RESOLUTION NO. _____

A RESOLUTION OF THE CITY COUNCIL OF THE CITY OF MESA, MARICOPA COUNTY, ARIZONA, APPROVING A MODIFIED SITE PLAN OF CERTAIN PROPERTY LOCATED AT 809 NORTH DOBSON ROAD (Z15-012). THIS REQUEST WILL ALLOW THE DEVELOPMENT OF A CONVENIENCE STORE AND GAS STATION ON THE PROPERTY AND PROVIDE PENALTIES FOR THE VIOLATION THEREOF.

(Revised Site Plan Dated July 2, 2015)

PROJECT
CST CORNER STORE #1676
809 N DOBSON ROAD
MESA, AZ
PRELIMINARY SITE PLAN

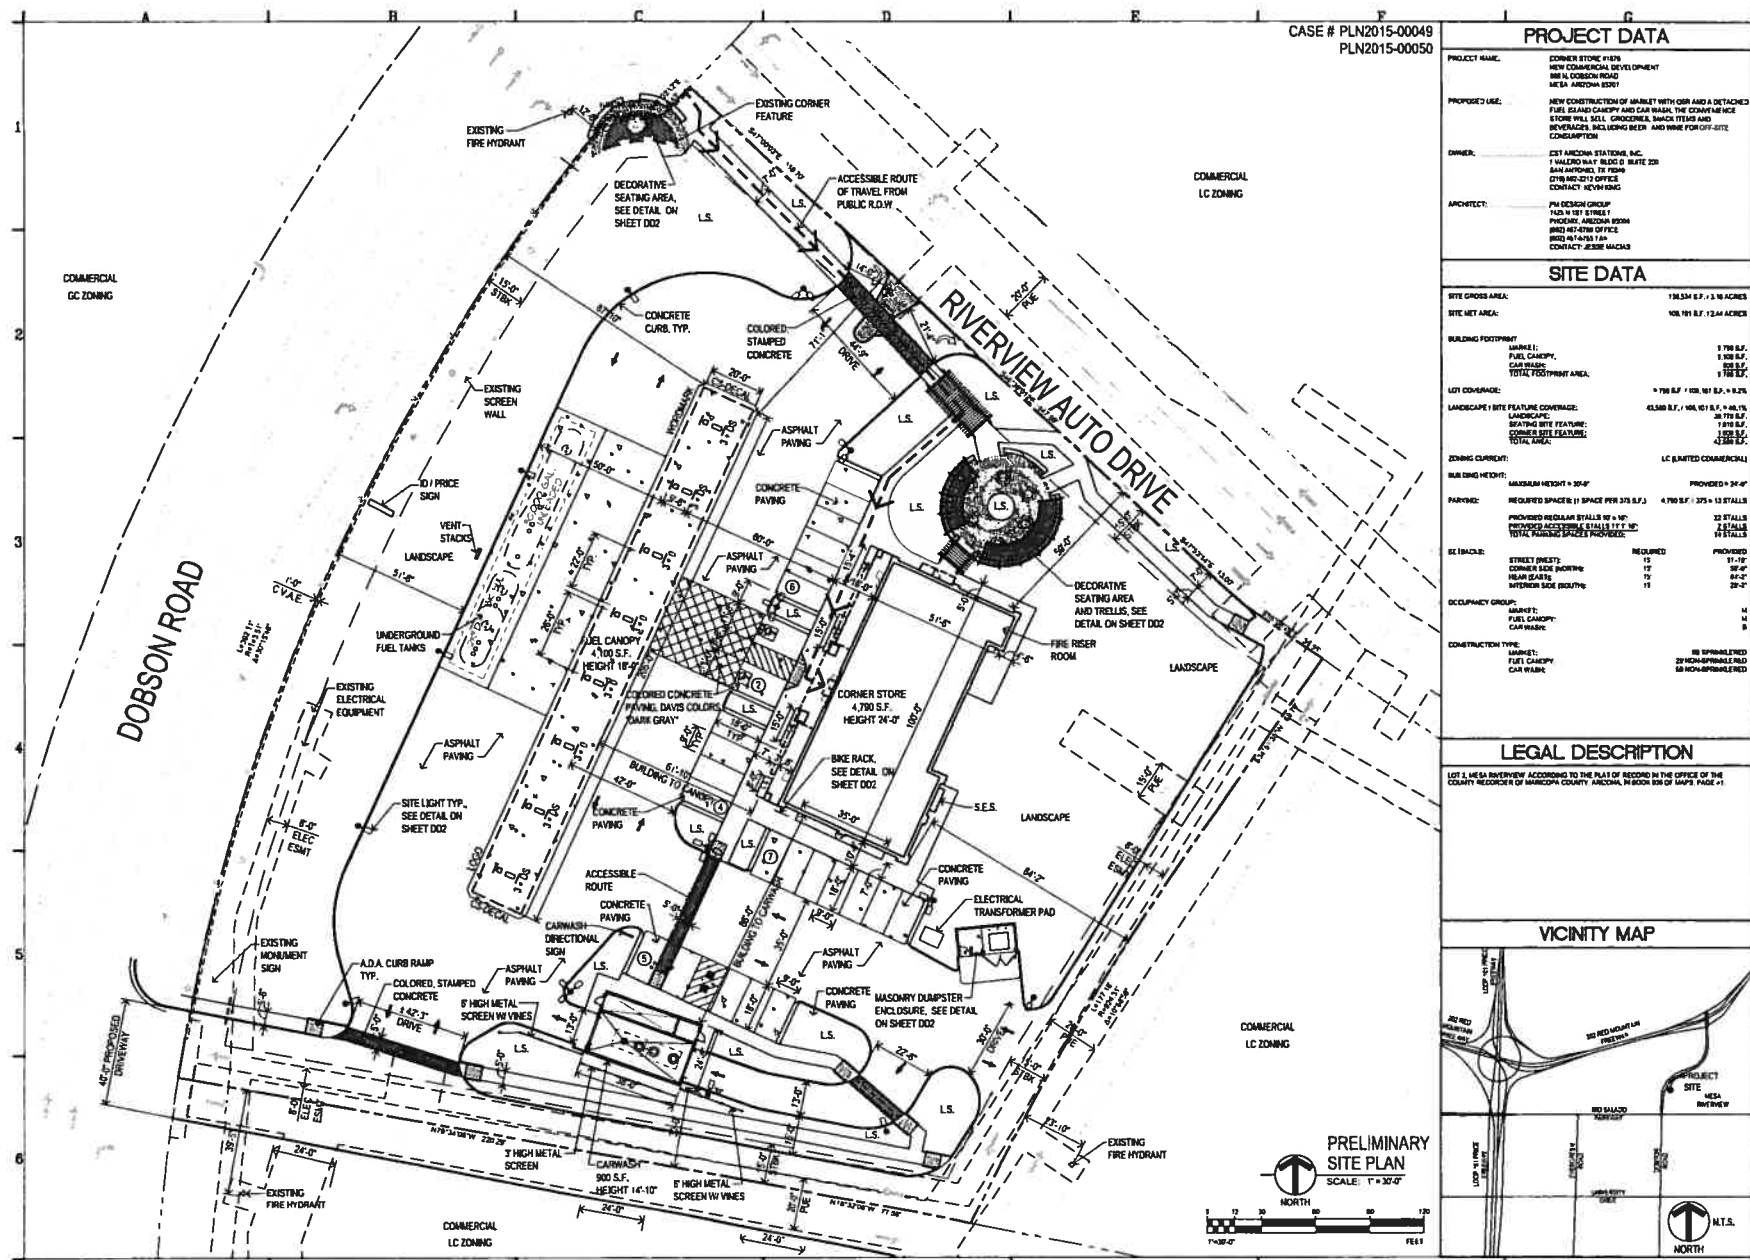
2. Compliance with the project narrative and revised site plan attached as Exhibit A, except as modified in this section:
 - a. Provide upgraded surface materials such as pavers or stamped concrete in all pedestrian areas that cross a drive aisle.

- b. Except where needed to accommodate fuel trucks, reduce driveway widths to be proportionate to vehicular circulation pattern, typically 24 feet.
 - c. Adjust the design of the "pork chop" to ensure traffic can only make a right turn when going in to the property or out of the property.

- d. Engineering Department approval of the extended pedestrian refuge area at the southeast corner of the intersection of Dobson Road and Mesa Riverview Drive.

6. Provide alternative to pipe bollards such as concrete bollards or design elements integrated with the fuel pump and column design.
 7. Mechanical equipment needs to be screened 100% by building parapets, not separate rooftop elements.
